**Re: Noise and Vibration Impact Study Addendum Letter
601 Scottsdale Drive, Guelph, Ontario
RWDI Reference No. 2302908**

Noise and Vibration Study Comments and RWDI's Responses

601 Scottsdale Drive, Guelph
Project No. 2302908

Figure: C3

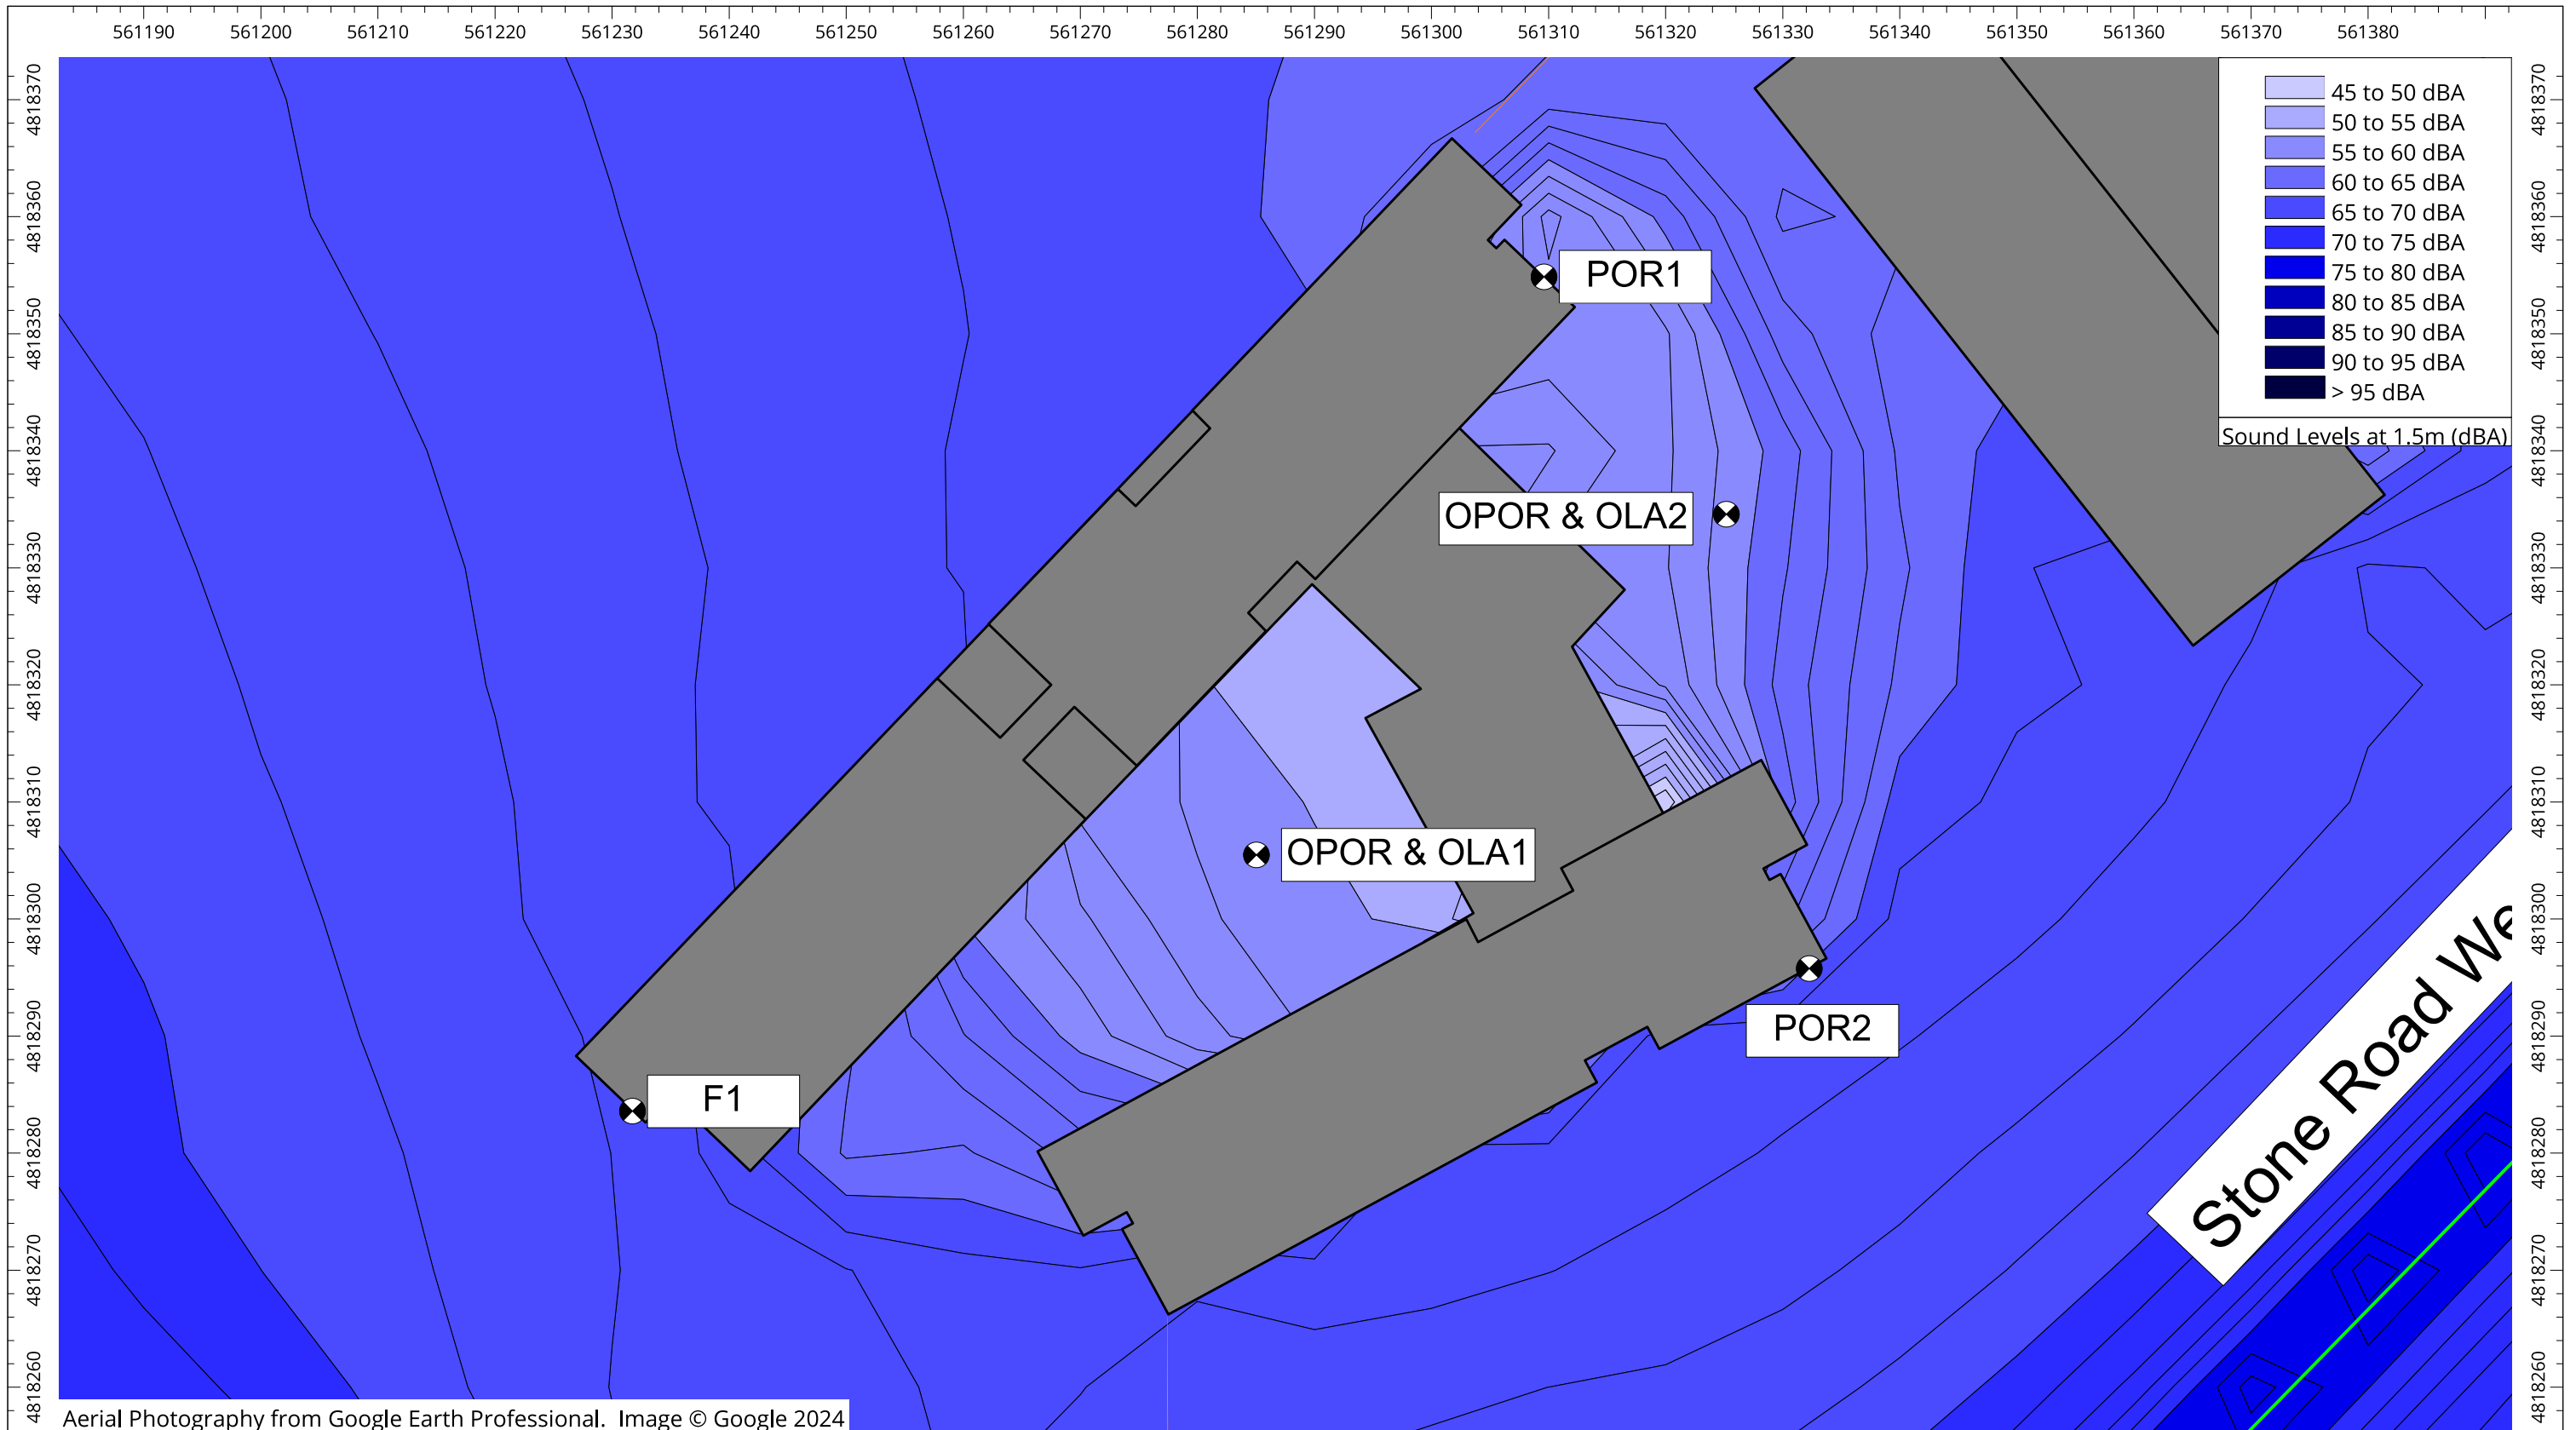
14	Page 14 - Class 2 (NPC-300)	18-Dec-23	ZBA	RWDI	RWDI Response: See response to comment #1.	See response to comment #1.
15	Page 43 - The posted speed limit changes from 80 to 70 (north bound) in front of this site: using 80kph would be more conservative and likely closer to the 85th percentile speed (this would also simplify the calculation to a single Hwy6 segment)	18-Dec-23	SPA	RWDI	RWDI Response: As per request, this will be updated in our analysis. The changes in results will be insignificant. The updated analysis will be included with the SPA.	Added comment about evaluating all of highway 6 at 80 km/h in Section 3.1.1
16	Page 43- Please provide dimensions on a sketch: the source-receiver distance used does not appear to be accurate based on the included sketches.	18-Dec-23	SPA	RWDI	RWDI Response: This sketch can be provided, but the dimension used is to the centreline of Highway 6 since both directions are modeled together. This will be clarified in the updated report for SPA.	Added figure C3 in Appendix C.

17	Page 44 - Exposure angles for the segments of Stone Road appear to be reversed (east vs west)	18-Dec-23	SPA	RWDI	RWDI Response: This has been noted and corrected. The results have been confirmed to remain the same. Updated calculations will be provided for SPA.	Updated sample calculation in Appendix C.
18	Page 44 - This segment of Stone Road is not at 0% gradient	18-Dec-23	SPA	RWDI	RWDI Response: This area has an average gradient of approximately 1% from NW to SE. The gradient will be updated in the model, but this change in gradient will not change the results. Updated calculations will be provided in the report for SPA. According to the as-built plan and profile for Stone Road, the average gradient is approximately 2%, with portions approaching 4%.	Changed to using 2% gradient for the section of Stone road east of Highway 6. Included in Stamson calculation in Appendix C.
19	Page 44 - Please provide dimensions on a sketch: the source-receiver distance used does not appear to be accurate based on the included sketches.	18-Dec-23	ZBA	RWDI	RWDI Response: See response to comment #16. One comment was for s-r distance to Hanlon, the other is to Stone; please provide sketches supporting the s-r distances used for both transportation sources.	Added figure C3 in Appendix C.
